Access Compliance Report

Public Rights-of-Way

(Curb Ramps)

Intersection ID: 10015275	Main Street: HARRIS_CORNERS_PY	Cross Street: N/A	Location: SW
ADA ID: 1E0370B2B037	Ramp Type: PerpDiag	Initial Pass/Fail: Fail	Overall Compliance: No
Severity Score: 35			
Codes/Mitigation Info/Possible Solution		Field Measurements/Component Compliance

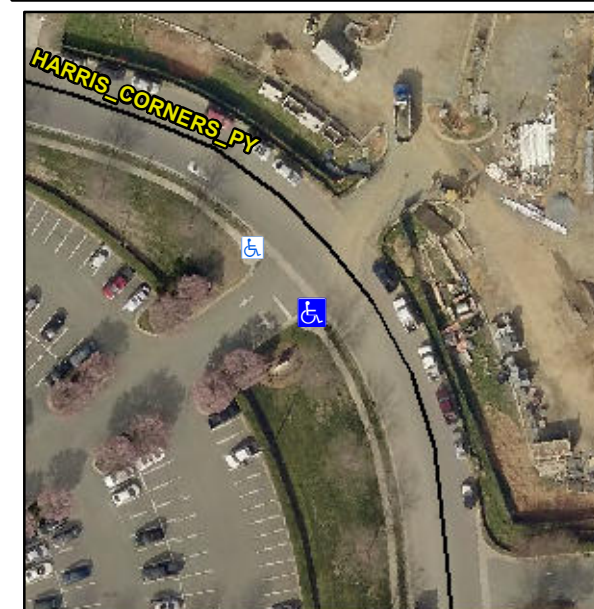
Compliance	Description	Data	Compliance	Description	Data
N/A	Ramp Length (in)	76.0	Yes	Ramp Slope (%)	5.4
No	Ramp Width (in)	30.0	Yes	Ramp XSlope (%)	1.3
N/A	Flare Type LT	N/A	N/A	Flare Type RT	N/A
N/A	Flare Slope LT (%)	N/A	N/A	Flare Slope RT (%)	N/A
N/A	Flare Traversable LT?	N/A	N/A	Flare Traversable RT?	N/A
N/A	Landing Length (in)	N/A	N/A	DWS Provided?	N/A
N/A	Landing Width (in)	N/A	N/A	DWS Contrast?	N/A
N/A	Landing Slope (%)	N/A	N/A	DWS Length (in)	N/A
N/A	Landing X Slope (%)	N/A	N/A	DWS Full Width?	N/A
N/A	Landing Curb? (Y/N)	N/A	N/A	DWS Offset (in)	N/A
N/A	Shared Landing?	N/A			
N/A	Gutter Ponding?	N/A	N/A	Gutter Slope (%)	N/A
N/A	Gutter Lip Ht (in)	N/A	N/A	Gutter X Slope (%)	N/A
N/A	Painted X Walk1?	No	N/A	Painted X Walk2?	No
	X Walk 1 Direction	To E		X Walk 2 Direction	To NW
N/A	X Walk 1 Width (in)	N/A	N/A	X Walk 2 Width (in)	N/A
	X Walk 1 Slope (%)	1.1		X Walk 2 Slope (%)	0.8
	X Walk 1 X Slope (%)	0.6		X Walk 2 X Slope (%)	1.1

Remove & Replace Curb Ramp With Two New Directional Ramps or Equivalent.
